Workman® 4000 Series 4wd

Model/Serial Range: Model Number: Serial Numbers:

Subject: Leakage at Lash Adjusting Nut of Steering Gear.

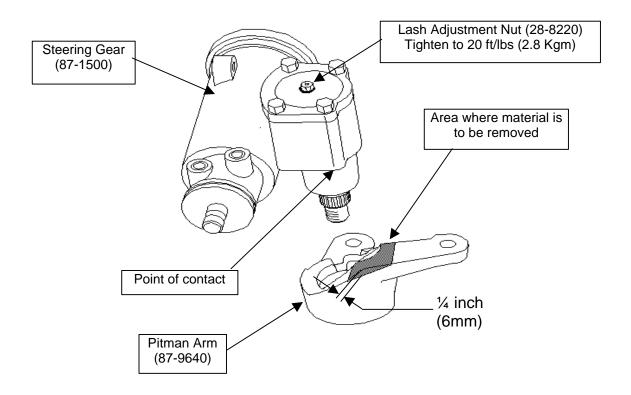
Interference between Pitman Arm (87-9640) and the Steering Gear Casing due to machining variances of the tapered spline connection may cause the Lash Adjustment Nut to loosen and create a hydraulic fluid leak.

If this issue exists on your unit, the Pitman Arm may be removed and modified to provide clearance as demonstrated below. Be sure to use the torque values listed below during assembly and installation. Assistance with this repair is available through your local Toro distributor.

Note: Torque Retaining Nut to 180-210 ft-lbs (25-29 Kgm)
